Final  
Environmental Impact Report

# Capitol Annex Project

State Clearinghouse No. 2019049066

## USE ATRIUM AND EXISTING SIXTH FLOOR, ADD UNDERGROUND SPACE THREE SIDES OF EXISTING ANNEX

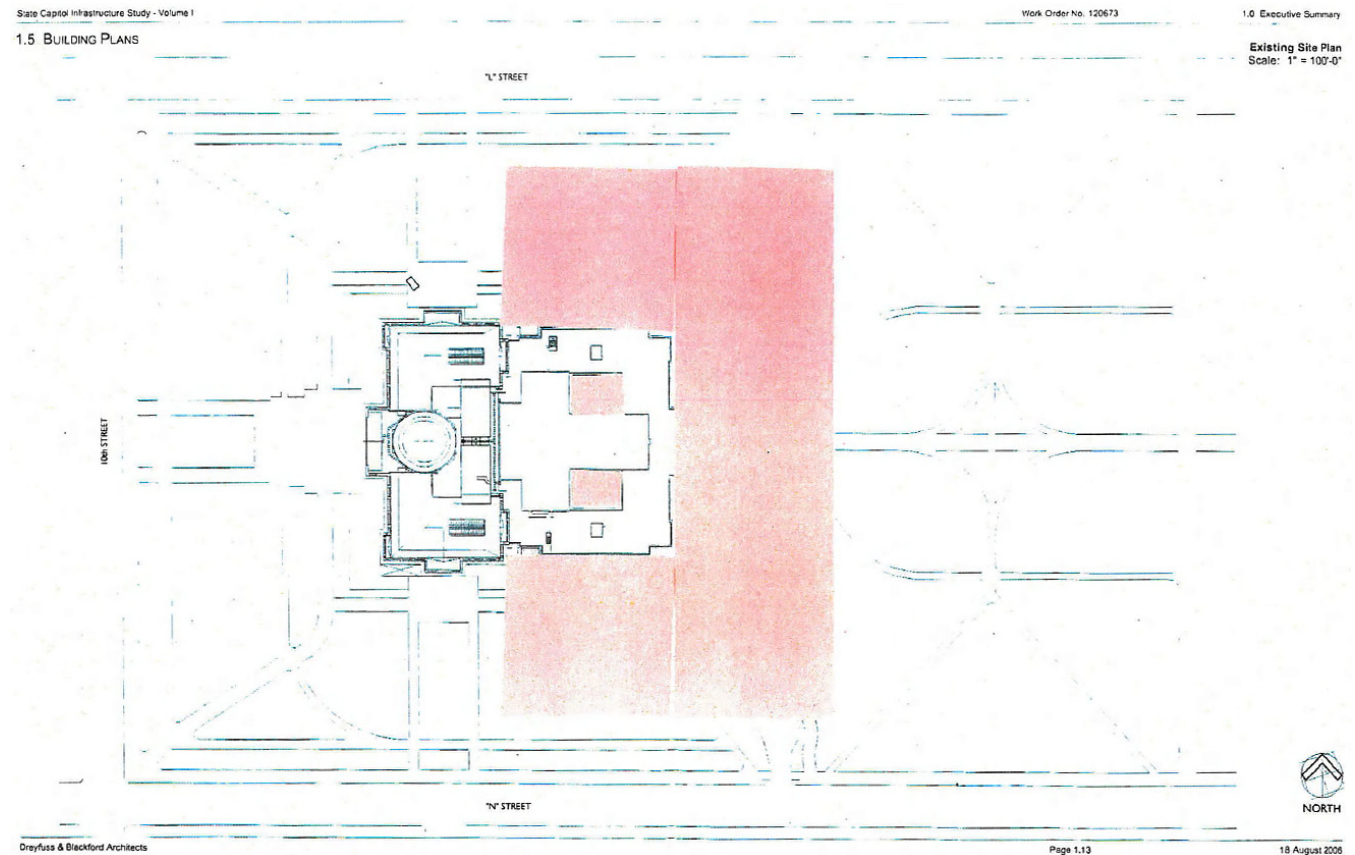
If the atrium spaces were utilized, and the sixth floor fully used, the program could be met by adding approximately 230,000 sf of underground space around three sides of the existing Annex.

Please see Master Response 2.

## MOVE ANNEX TO EAST, USE ATRIUM AND SIXTH FLOOR, ADD SPACE IN BETWEEN

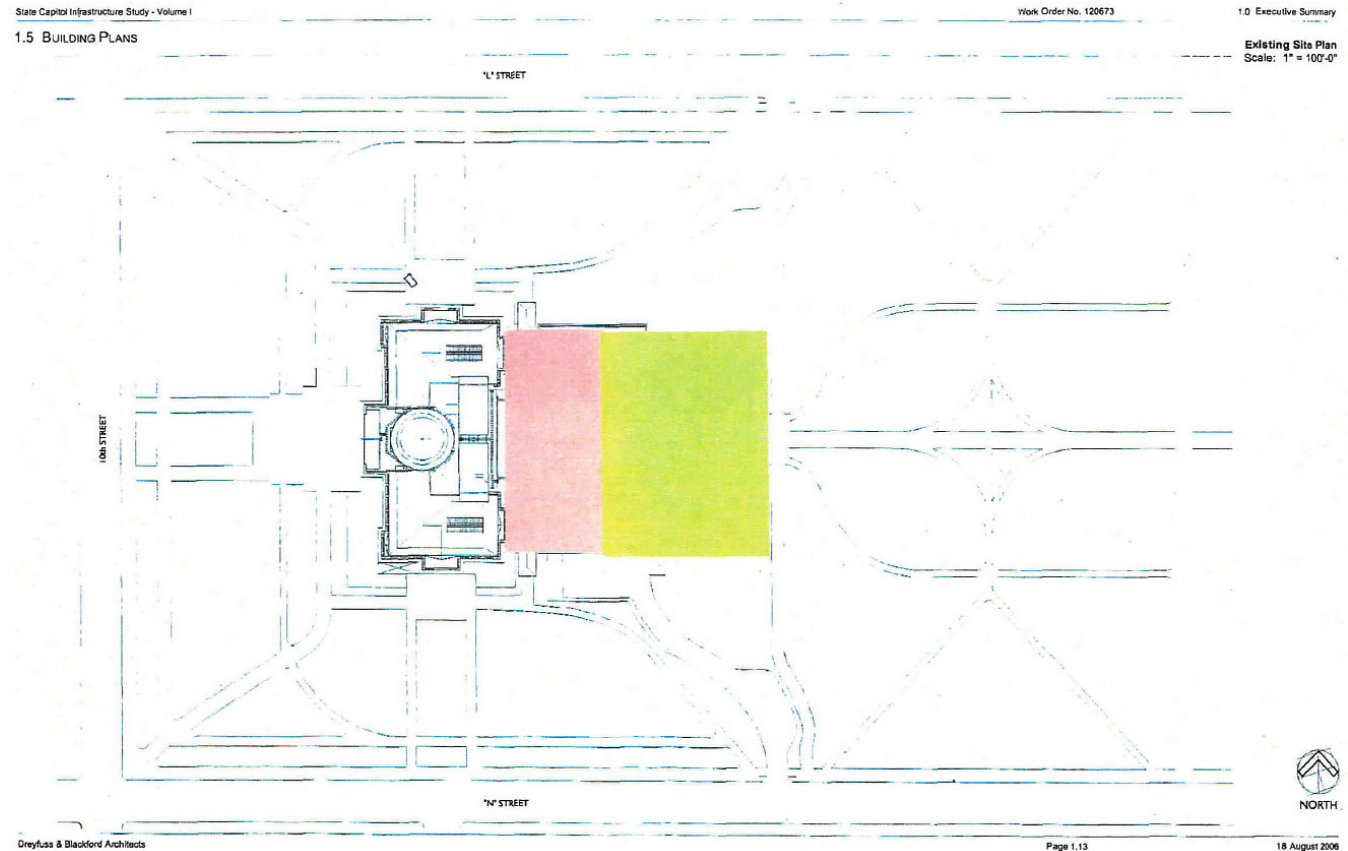
If the atrium spaces were utilized, the sixth floor fully used, and if the existing Annex was moved to the east, the program could be met by adding basement plus five stories in between relocated annex and west wing, better accommodating floor elevation differences.

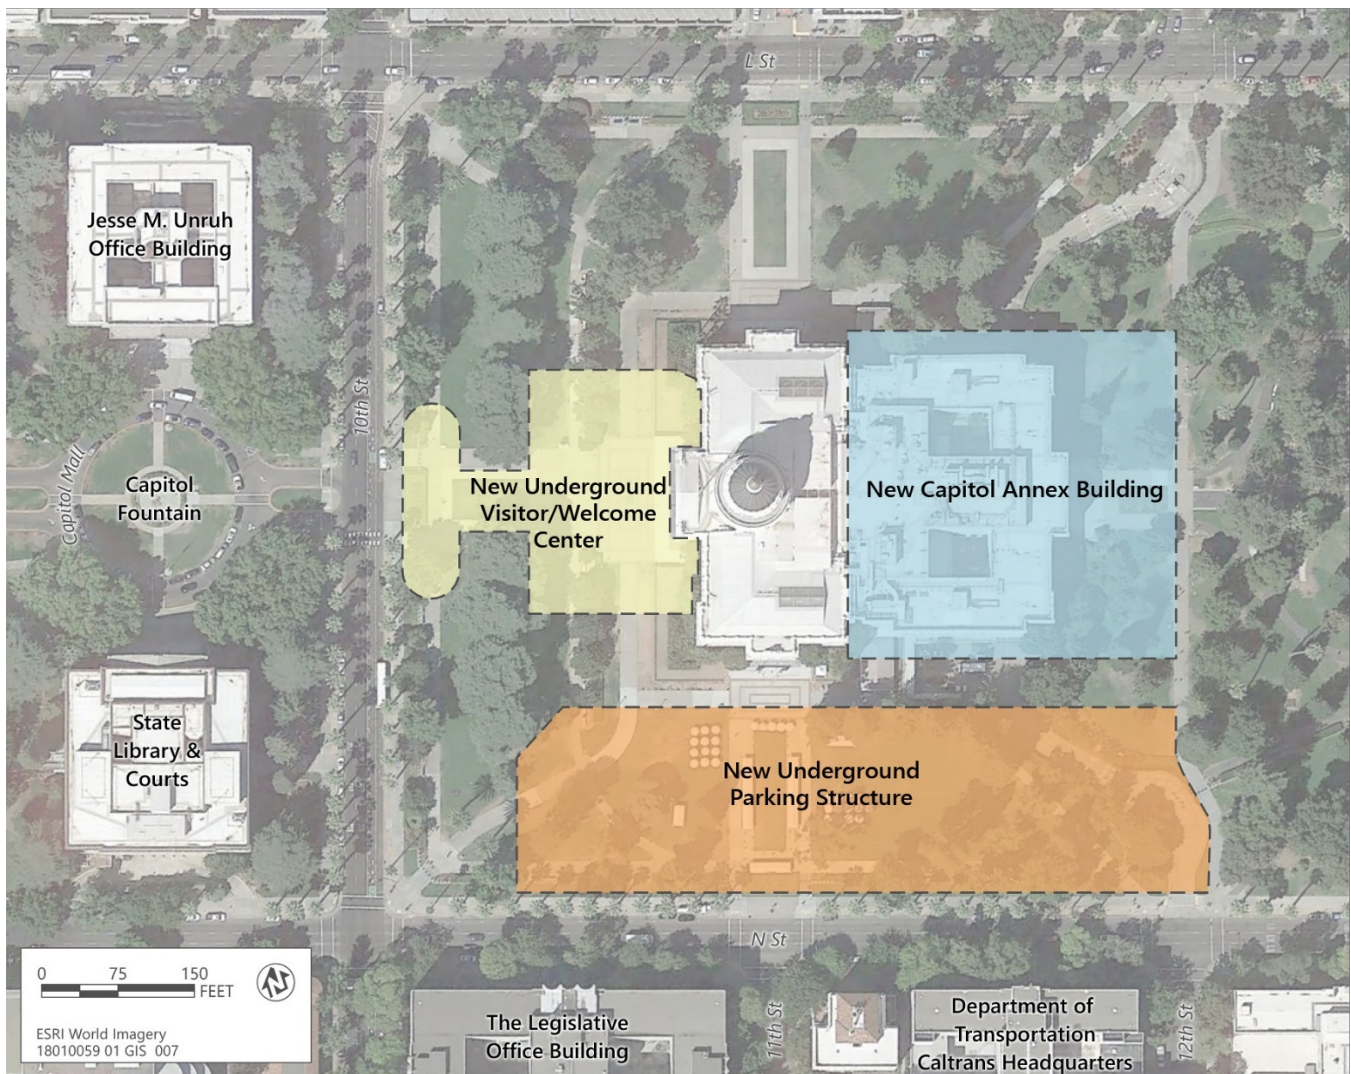
As shown in Figure 3-3 of the Recirculated Draft EIR below, the revised locations of the Visitor/Welcome Center and underground parking structure have potential for damaging five of the historic Deodar cedars, as well as causing removal of multiple other trees. There are 34 trees within the outline of the Visitor/Welcome Center project below. An additional 39 are within the outline of the underground parking structure. Thirty-three more are within the new Annex outline, for a total of 106 trees to be removed or relocated. This represents over 1/10th of all trees in the park. This count does not include those trees within 50 ft of project outlines as mentioned in the original DEIR as part of a protection zone.

For four of the cedars, Figure 3-3 shows that the Visitor/Welcome Center construction will occur well inside the dripline of these trees and on both the east and west sides.
